## 6. ART IN PUBLIC PLACES

ADDENDUM #1  
CITY COMMISSION  
03/09/15

MEDITERRANEAN VILLAGE  
AT PONCE CIRCLE

# FLOOR PLAN - LEVEL 6

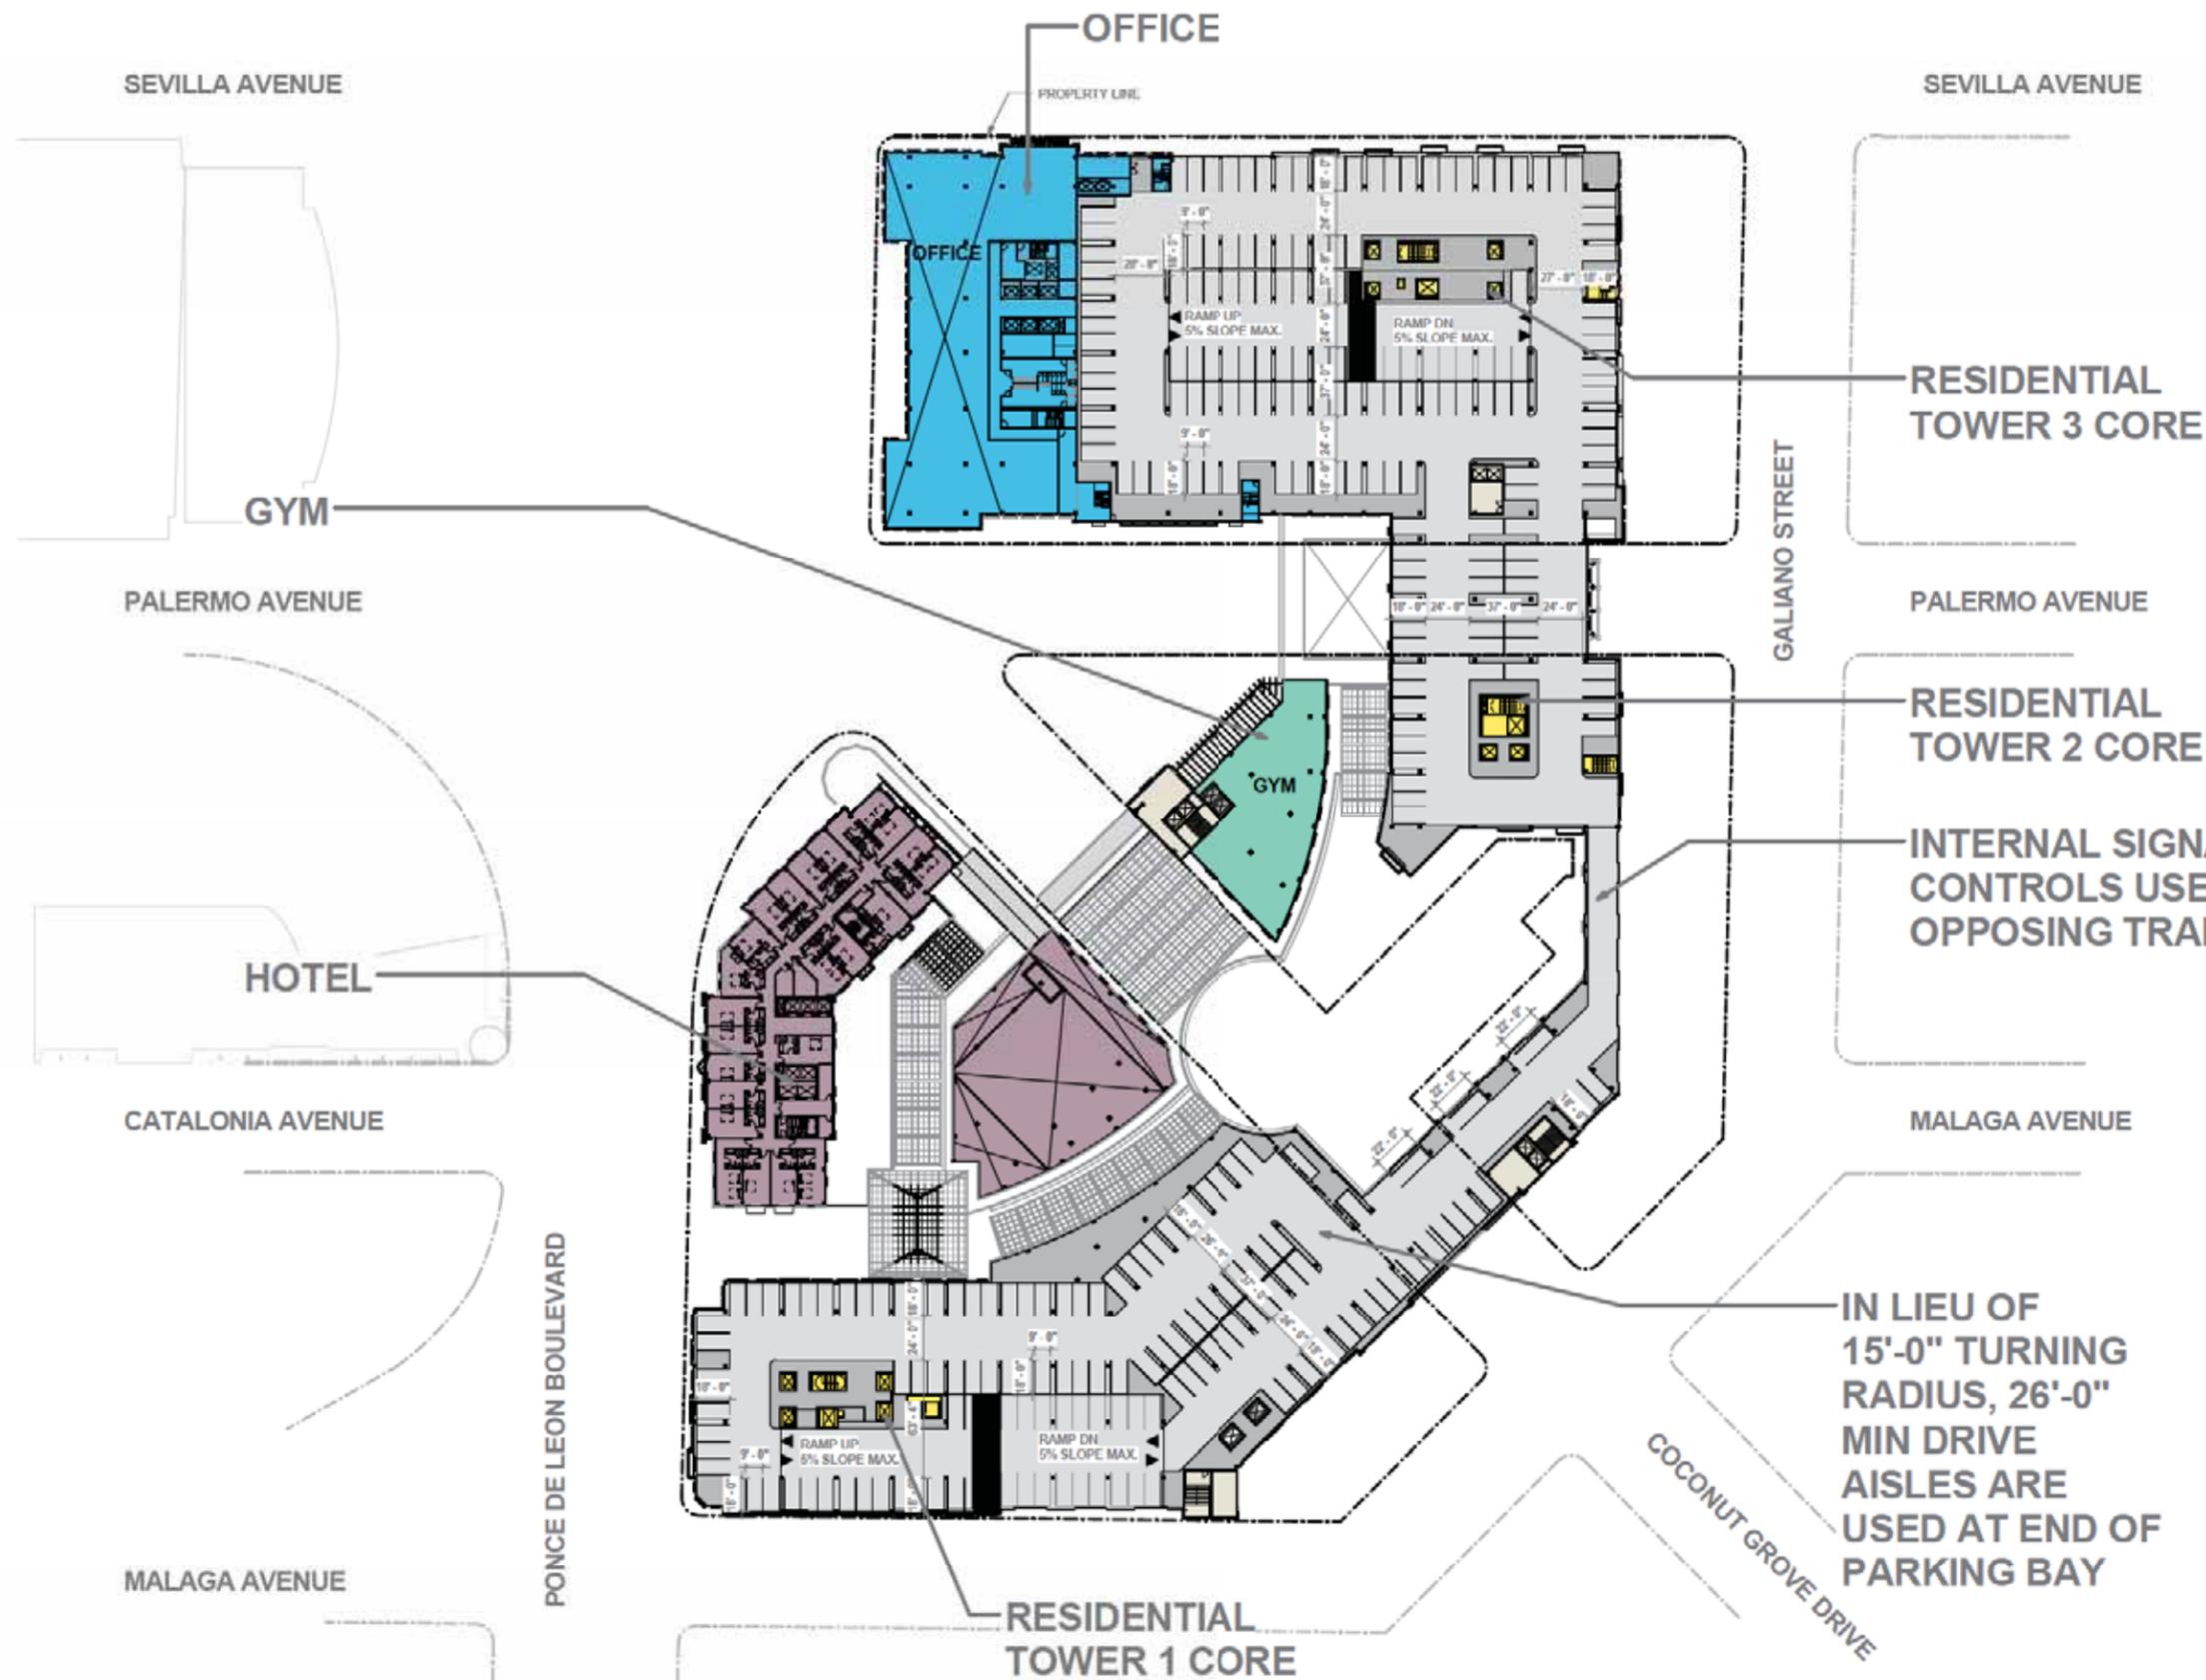
- A. The inside end of each drive aisle needs a 15-foot radius to allow for simultaneous turns. This is good design practice and is required by Miami-Dade County.
- B. Ideally, the garage shouldn't have any "dead-ends." If there are dead-ends, then turnaround areas are needed, which generally requires removal of parking spaces.
- C. There are many areas that need to show if vehicular maneuverability works using AutoTurn, especially in the loading areas, the circular ramps, etc.
- D. There are columns that are in conflict with the vehicle maneuvers.
- E. The city zoning code for parking requirements needs to be met.
- F. There are areas where parking spaces conflict with ramp circulation.
- G. Vehicular cross connections on levels 3 through 7 are not adequate for two-way traffic.
- H. Ramp grades that do not have parking on them ideally do not exceed 10% and should not exceed 12%.

IN LIEU OF 15'-0" TURNING RADIUS, 26'-0" MIN DRIVE AISLES ARE USED AT END OF PARKING BAY
